SPECIFIC REQUIREMENT'S (Section- Project)
C/ENGG/SPEC/SEC-PROJECT/SPECIFIC REQUIREMENT REV NO 10

S.No.	Clause No.	Amended As (As per Specific Requirement Rev 10)
A. Section: GTR Rev 15		
1.	Clause 2.1 (a)	"All equipment/materials/items, as per <u>Annexure-K (Rev 01)</u>, as applicable under present scope of works, shall be procured and supplied from domestic manufacturers only with Minimum Local Content for individual items as listed in the above annexure. Any imported equipment/material/item/parts/component (comprising of embedded systems) to be supplied under the contract shall be tested in the certified laboratories to check for any kind of embedded malware/trojans/cyber threats and for adherence to Indian Standards as per the directions issued by Ministry of Power/Govt. of India from time to time. In case of such import from specified "prior reference" countries, the requirement of prior permission from the Govt. of India including protocol for testing in certified and designated laboratories by Ministry of Power/Govt. of India shall also be complied with by the contractor. The bidder/contractor shall list out the products and components producing Toxic e-waste under the contr

TYPICAL ARCHITECTURAL DRAWING OF SUBSTATION AUTOMATION SYSTEM (Without Process Bus) for New Substation

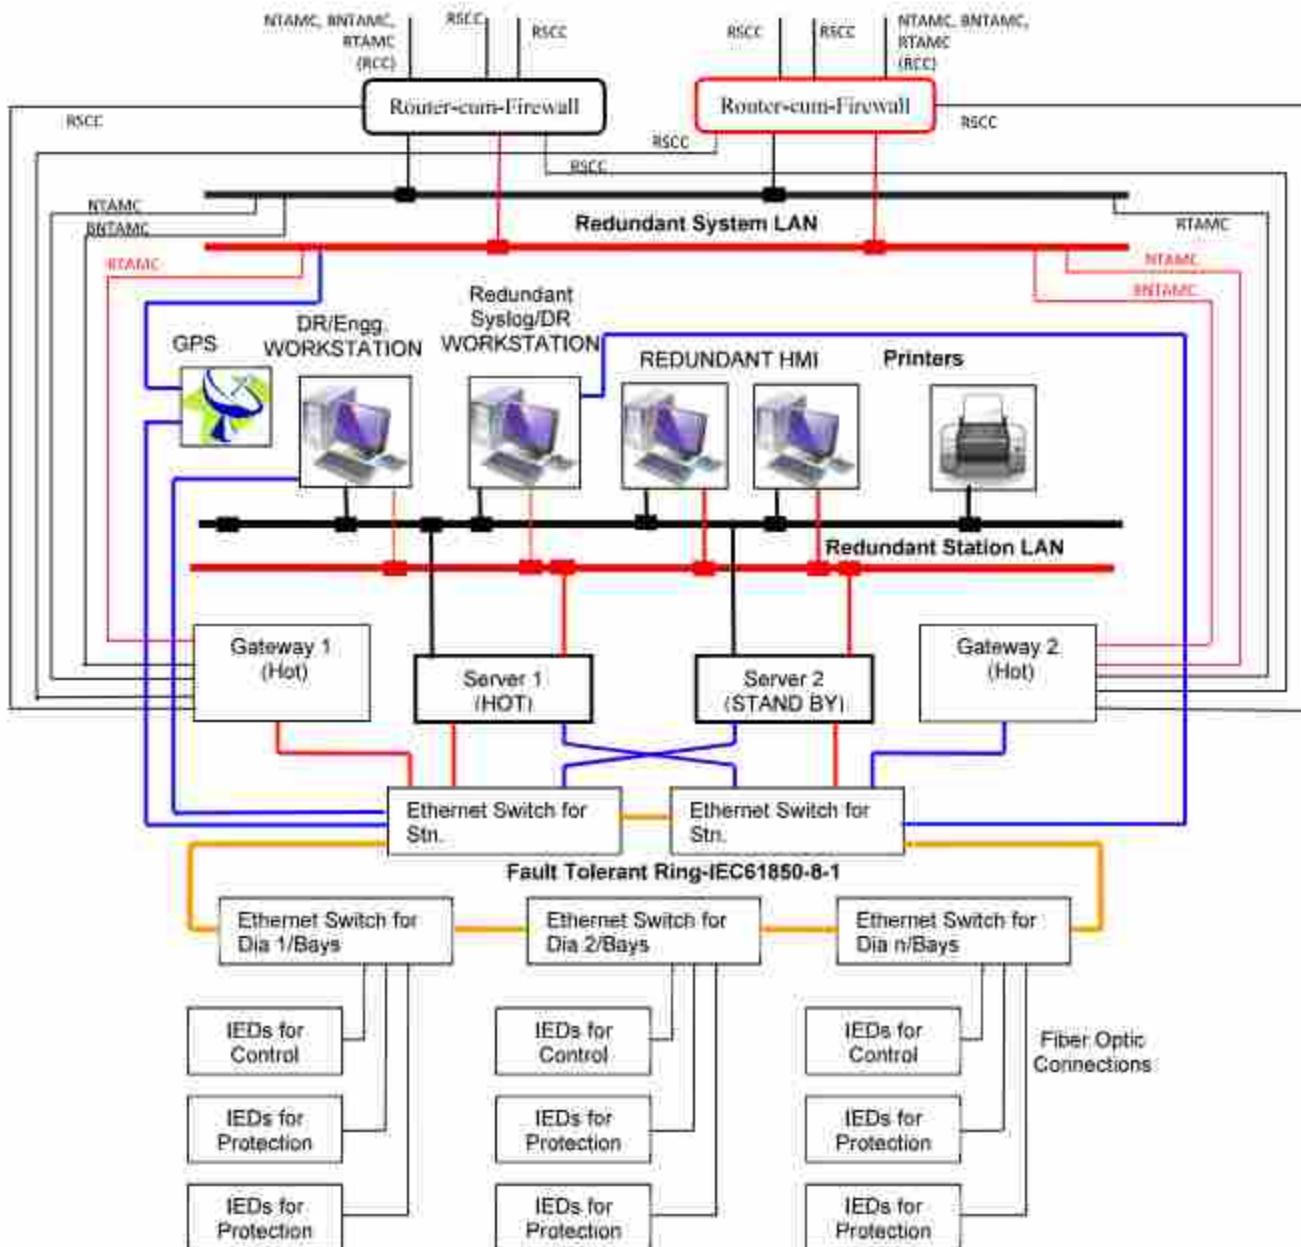
S.No.	Clause No.	Amended As (As per Specific Requirement Rev 10)
L.	Section SAS	Rev 04
1.	Typical Architectural Drawing of SAS (Without Process Bus)	TYPICAL ARCHITECTURAL DRAWING OF SUBSTATION AUTOMATION SYSTEM (Without Process Bus) stands replaced by Annexure-S5
